# UNITED STATES PATENT AND TRADEMARK OFFICE

10/596,847

<b>Office Action Summary</b>	<b>Application No.</b> 10/596,847	<b>Applicant(s)</b> MUSAEFENDIC, JASKO	
	<b>Examiner</b> JENNIFER STEELE	<b>Art Unit</b> 1794

## **DETAILED ACTION**

FIG. -1

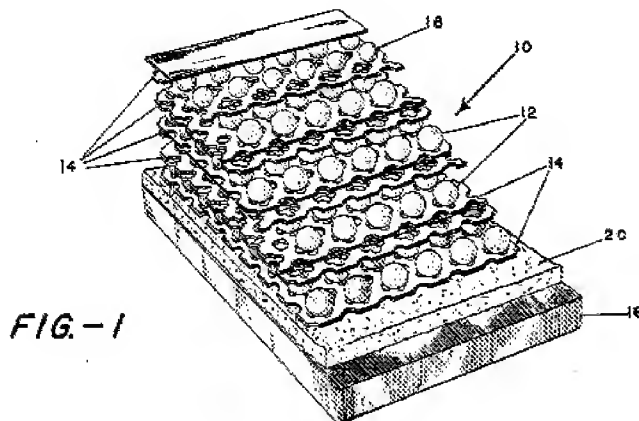
Cook teaches a multiply ballistic armor system comprised of layers of hard geometric objects tensionally restrained in their layers by fiber material interwoven about the objects and the objects and fibers are bonded together by adhesive (ABST). See Fig. 1 and 4 below.

Each layer of geometric objects is equated with a ply layer. Cook teaches multiply inner plies.

As to claim 64, Bjorksten differs and does not teach reinforcing plies made from the materials claimed. Cook teaches the geometric objects are tensioned together with fiber strands. The fiber strands are interwoven around so as to support each rod **70** in tension against impact (col. 6, lines 1-15). The fiber strands, shown in Fig. 4 as **76** are equated with Applicants claimed single fibre reinforcement and/or woven rovings.

FIG-4

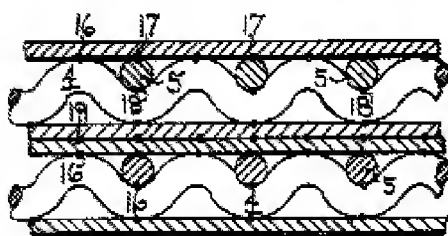
Hollis teaches a protective wall structure that resists penetration and impact. Hollis teaches outer layers of multilayer cloth with at least one inner protective inner layer defined by a rib-like formation defining a series of pockets. The pockets are filled with a polymer self sealing core structure (ABST). The polymer is equated with Applicant's polymer matrix. The structure of Hollis is shown in embodiments in Fig. 4 and Fig. 8 below.

FIG-8

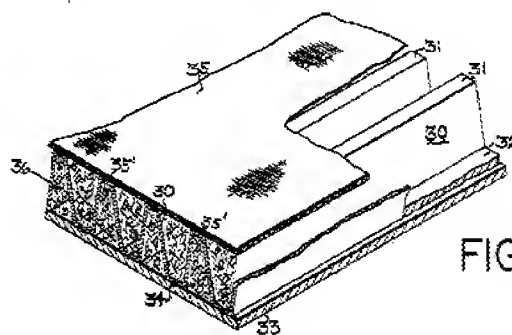
As to claim 68, Bjorksten differs and does not teach a polymer matrix formed from one of the claimed compounds. Hollis teaches the polymer matrix which fills the voids can be of a epoxy-urethane elastomer (col. 10, lines 25-28).

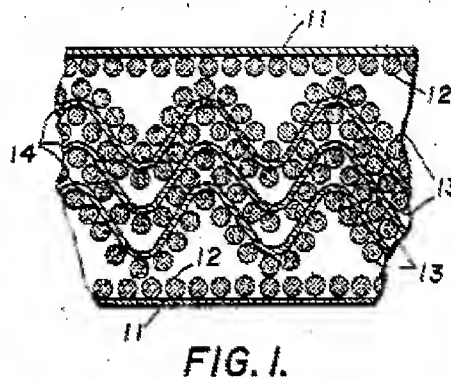
As to claim 71, Bjorksten teaches the laminate is created to dissipate force in a parallel direction (col. 1, lines 65-72). The dissipation of force in the laminate of Bjorksten is equated with Applicant's claim 71 where the loading is redistributed in a longitudinal direction to the main axis of said reinforcement plies.

Calfee Fig. 1

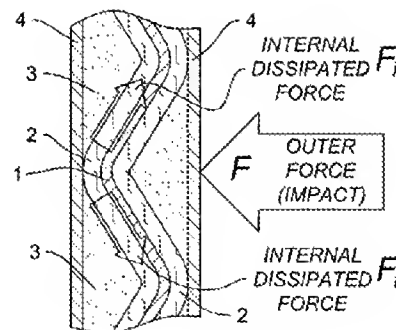
Calfee's laminate is show in Fig. 1 below where **11** is a metal foil layer and equated with Applicant's outer layers, **12** is a layer of glass fibers and equated with Applicant's inner plies, **13** are graphite fiber layers and equated with Applicant's inner plies and **14** are corrugated metal foil layers and equated with Applicant's dissipating elements.

Applicant's Fig. 2

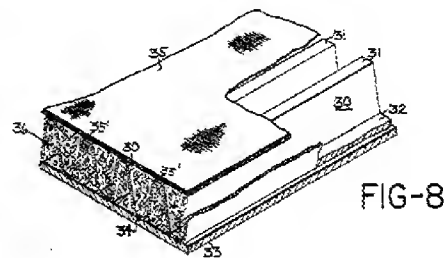
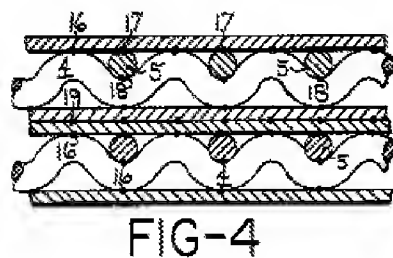
Calfee differs from the current application and does not teach a polymer matrix arranged to occupy all the volume not taken up by the layers.
